Addendum 3

Date: 7/12/18

New Restaurant, Banquet Center
& Corporate Offices at The Junction for:
Sugarfire Smoke House
600 West Main
Wentzville, Missouri 63385

SHEET
A2.4
ROOF PLAN
& DETAILS

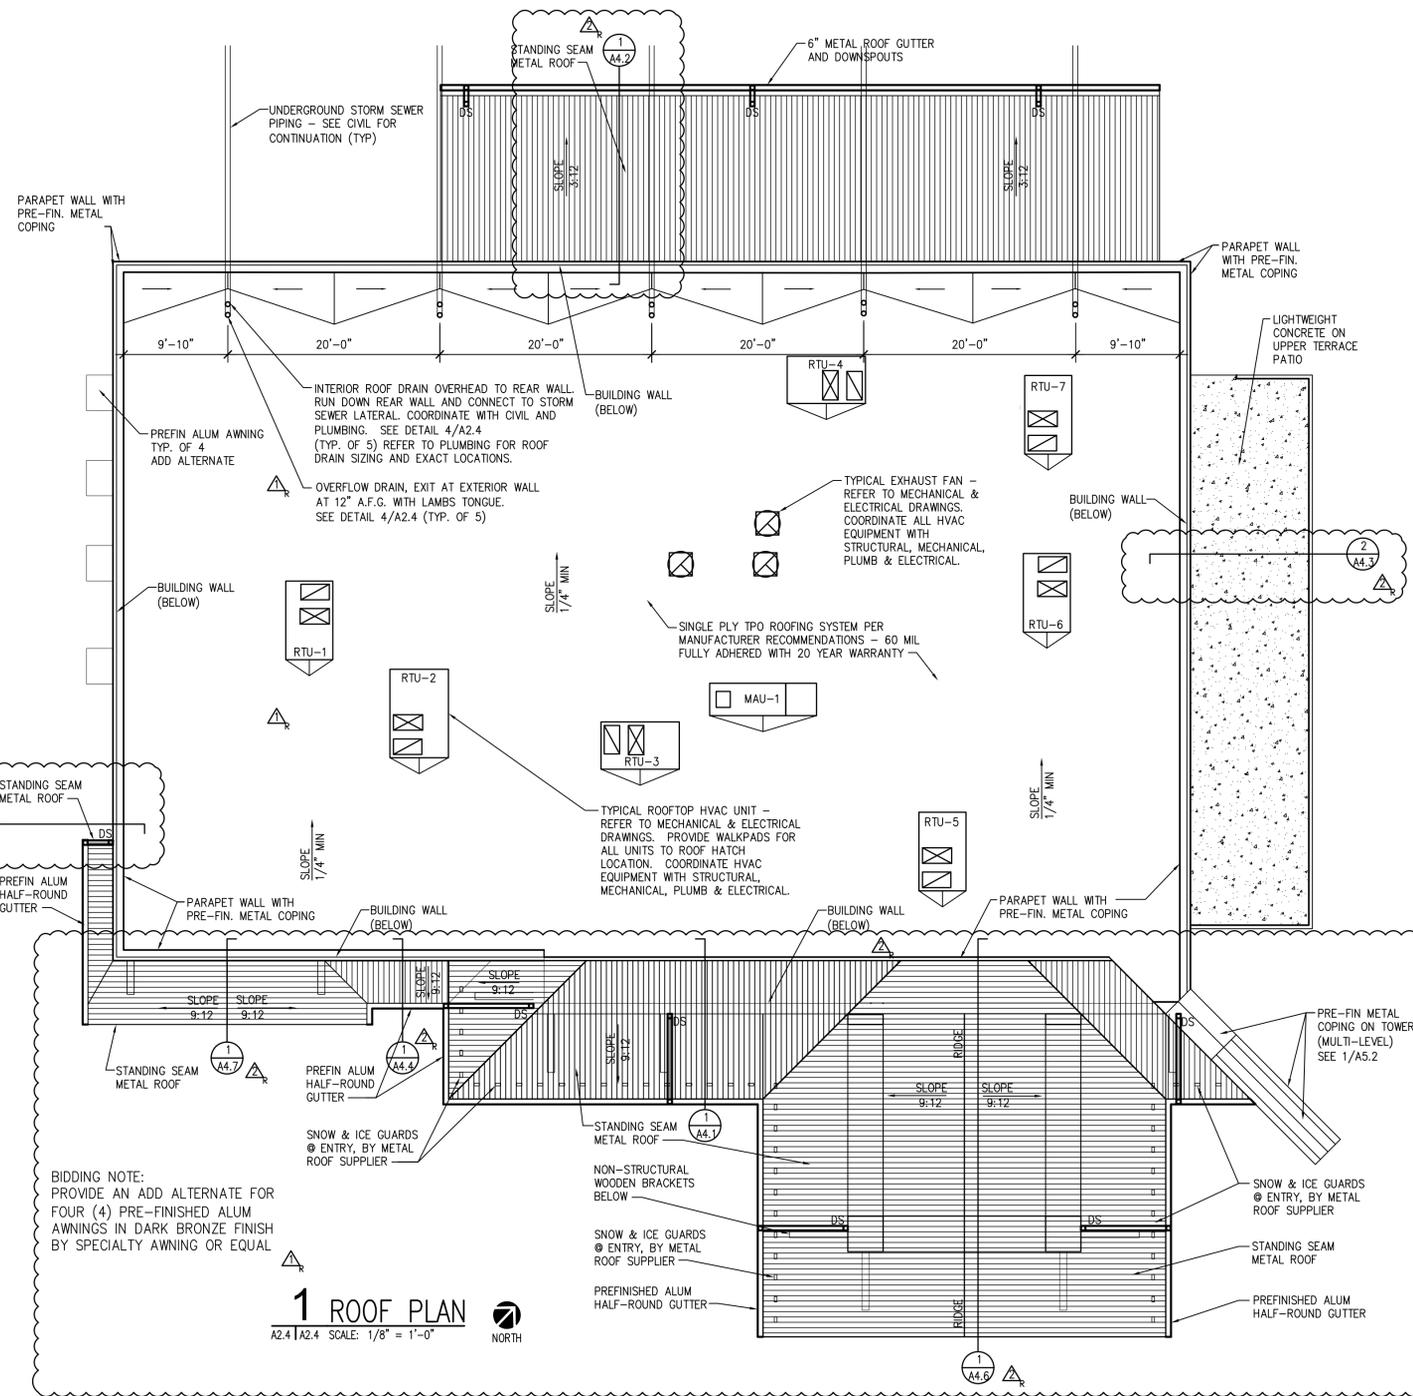
1. This project is not prevailing wage **Correct.**
2. This project is not tax-exempt **Correct.**
3. On the roof plan there is no wall detail notes that say what detail goes with what wall on the print **We will add Wall Section Cuts on the Revised Roof Plan.**

15. See Attached. This is a sketch of what I was asking about on Friday. Hopefully makes it a little clearer **See attached updated Roof Plan.**

SHEET
M1.0

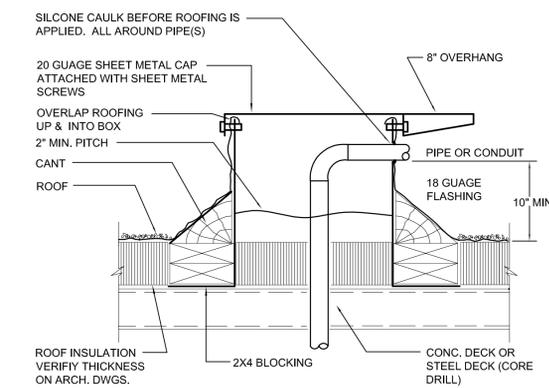
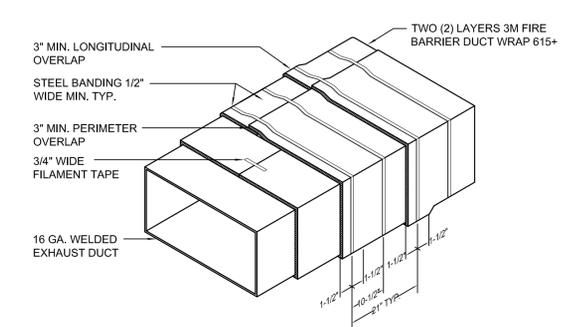
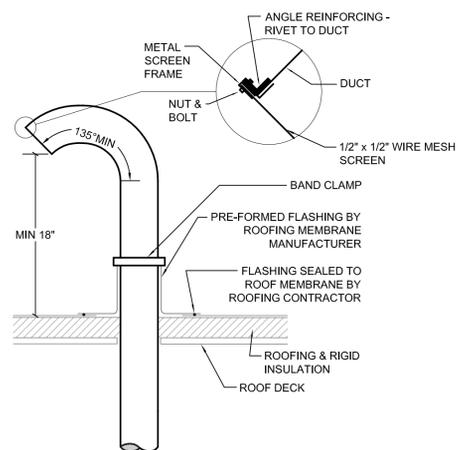
M1.0 – Add i2 insulation: i2 is a 2" wrap, similar to i1, but 2".

SHEET
M2.0

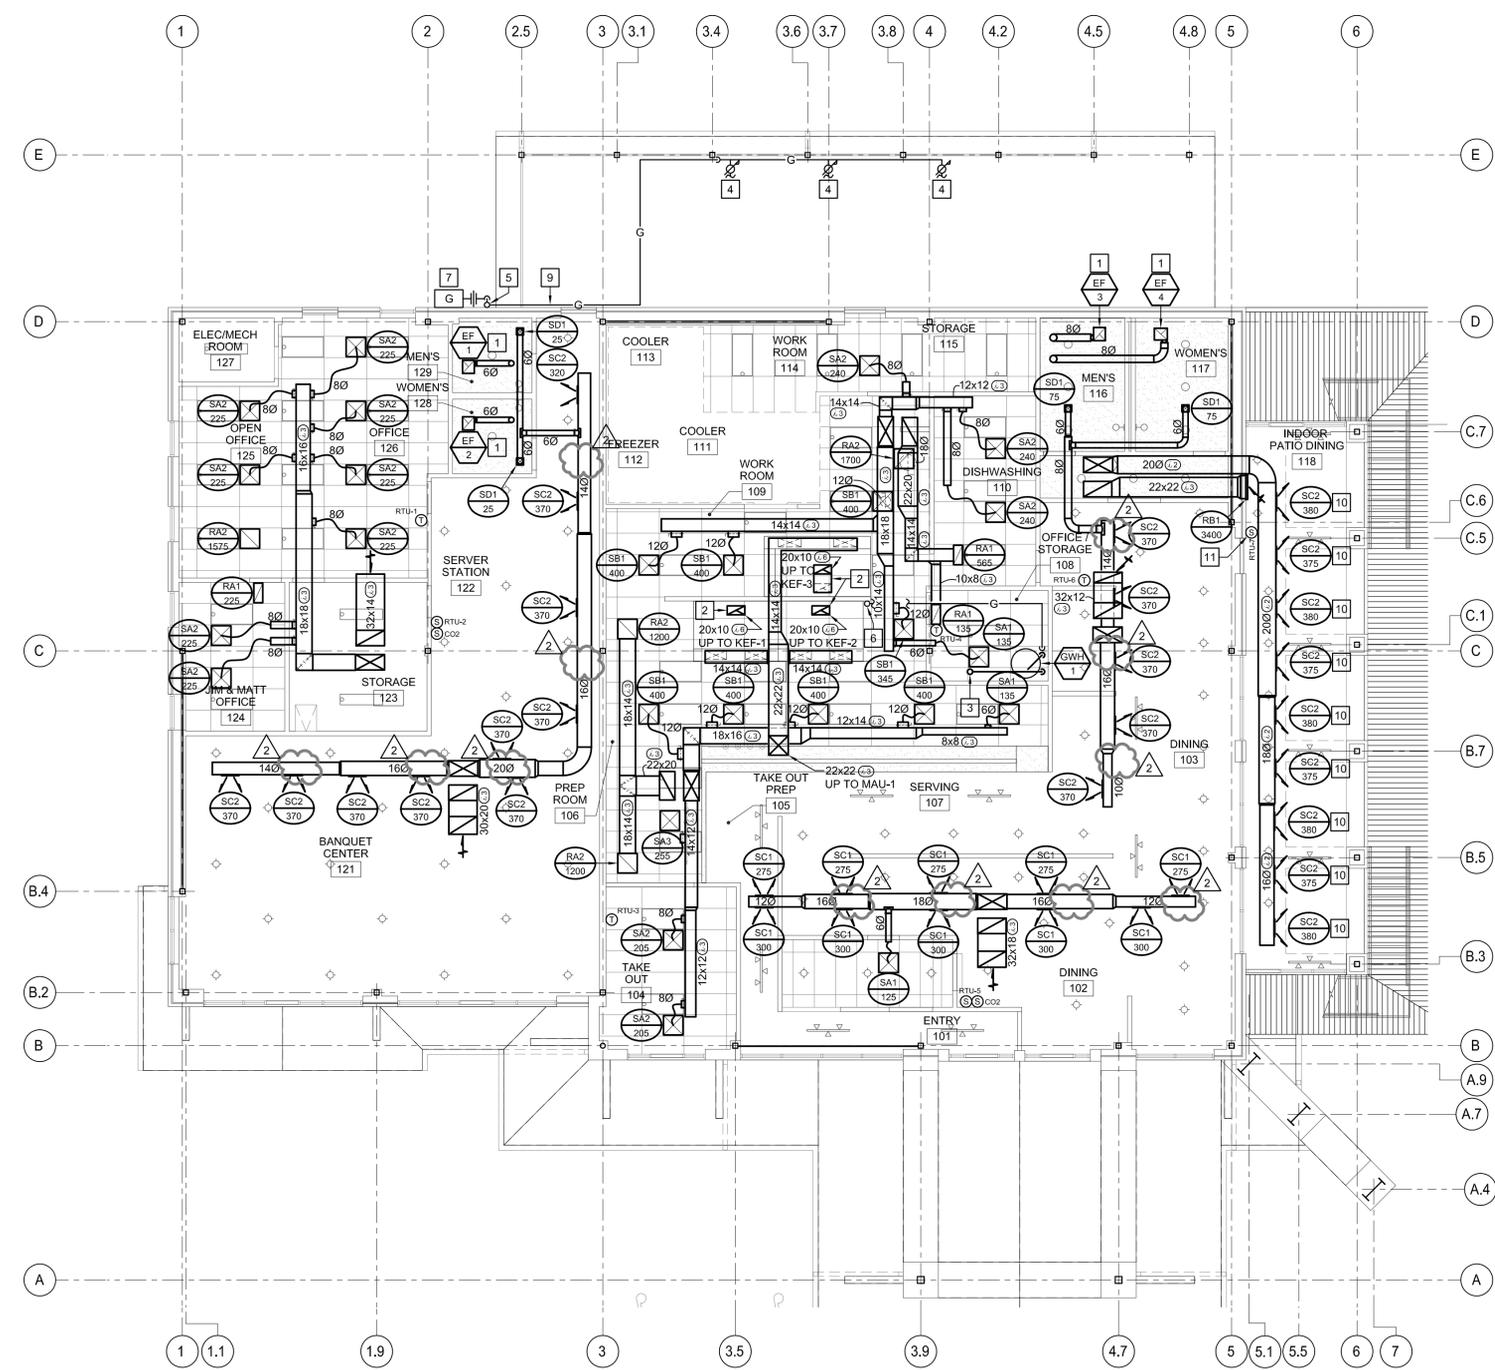
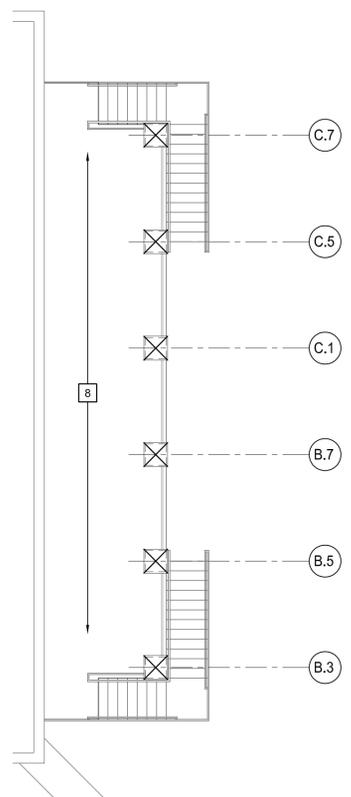
M2.0 – The exposed supply ductwork in Dining Hall 103 and Banquet Center 121 do not get insulation at all; the returns should be lined (i3). Ductwork in Indoor Patio Dining 118 shall be the only ductwork with i2. This area also gets the alternate bid for double-wall ductwork.
